Development Review Board

Tuesday, July 16, 2024, 5:00 PM

ZP-24-243; 165 Shelburne Street (RC, Ward 5) Champlain Housing Trust, Inc. / Donal Dugan

ZP-24-263; 1074 Pine Street (RL, Ward 5) South Meadow Apartments, LP / Liviya Kovacevic

Render Image - Top View

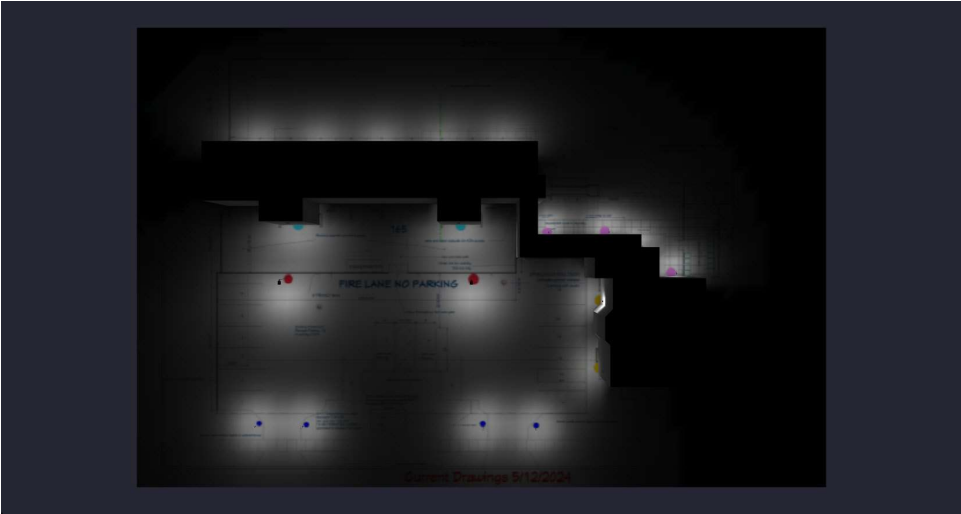
New outdoor lighting will illuminate building entries and the front parking area. Fixture cut sheets and a photometric plan have been provided. Proposed fixtures appear to be acceptable; however, some of the illumination levels are too high, and the photometric plan does not distinguish between the entryway and parking lighting environments. Entryway illumination needs to average 5.0 footcandles or less. Parking illumination is limited to 4.0 footcandles at any given point and needs to comply with a 20:1 uniformity ratio. Pole fixture mounting height is acceptable at 10.' A revised photometric plan is needed to comply with the outdoor lighting standards of Sec. 5.5.2.

Trailer Location

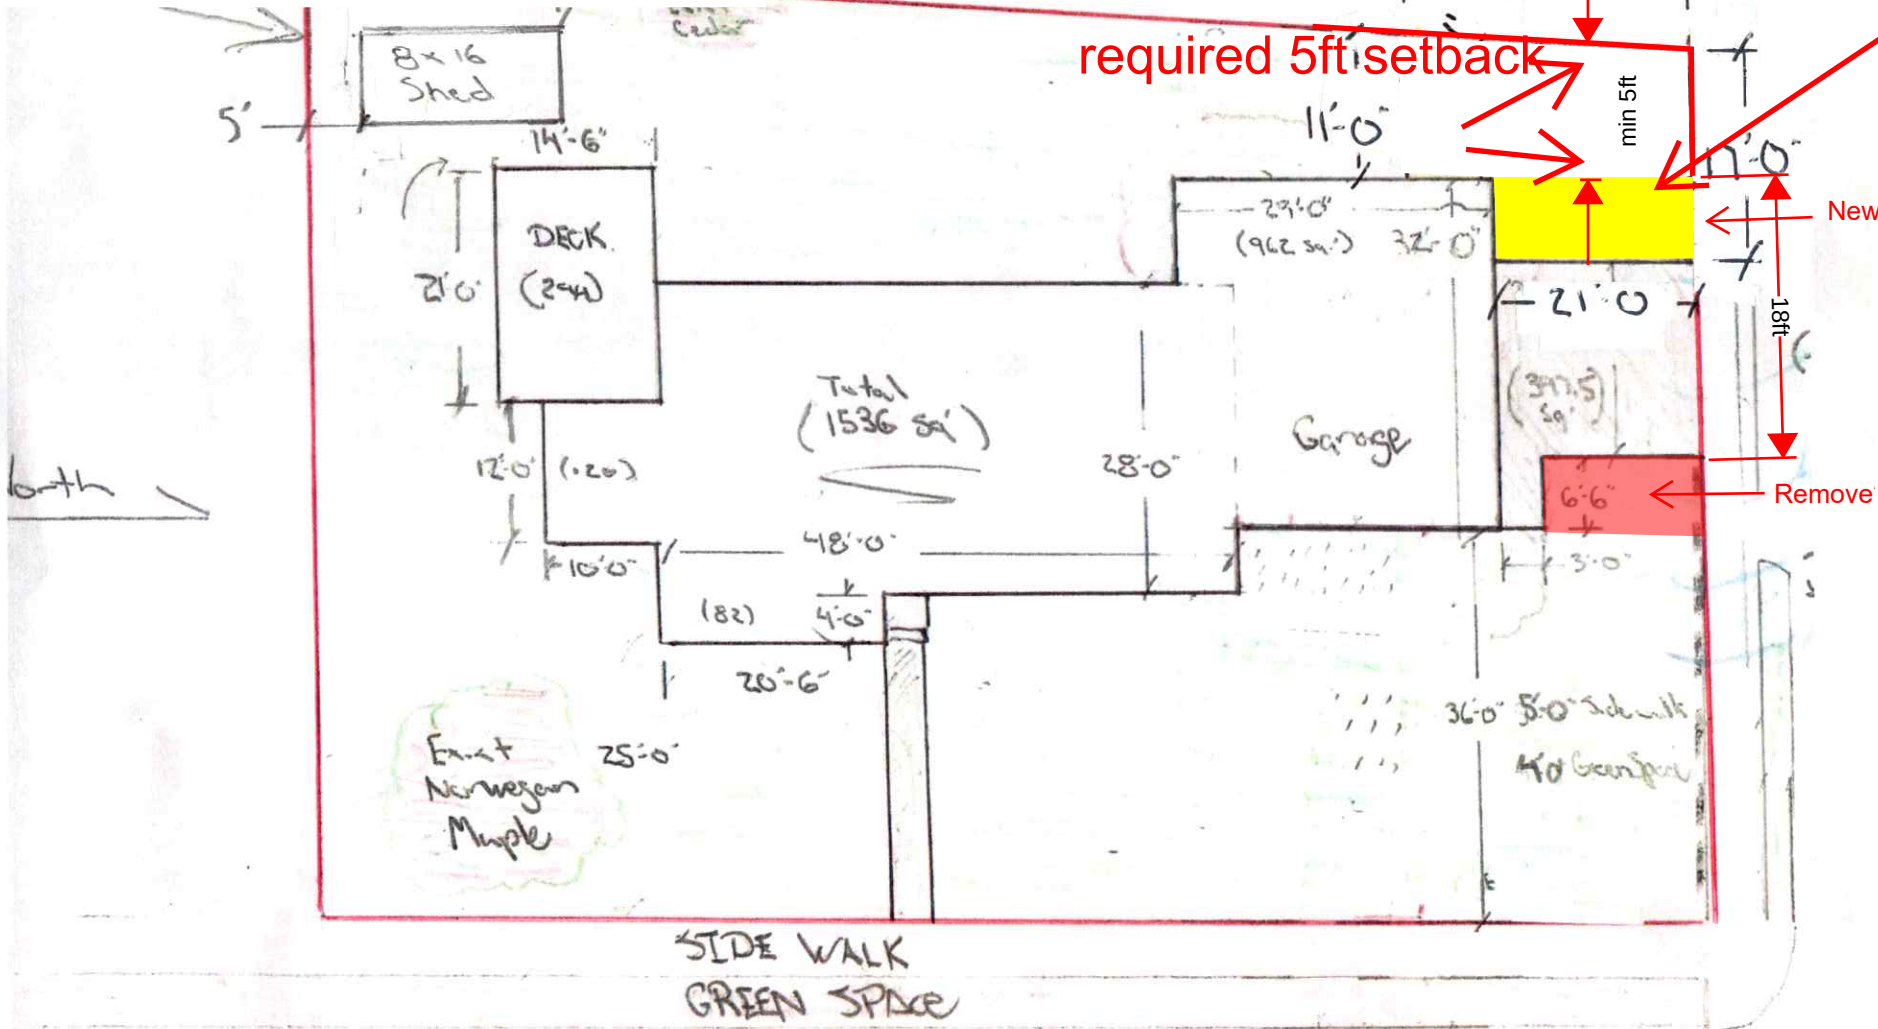
Residential density will not change, the existing single-family home will remain unchanged. The home occupation will be run out of a trailer, no dimensional changes will be made. Lot coverage is currently 32.4% and will increase to 32.5% remaining under the 80% maximum. **(Affirmative Finding)**
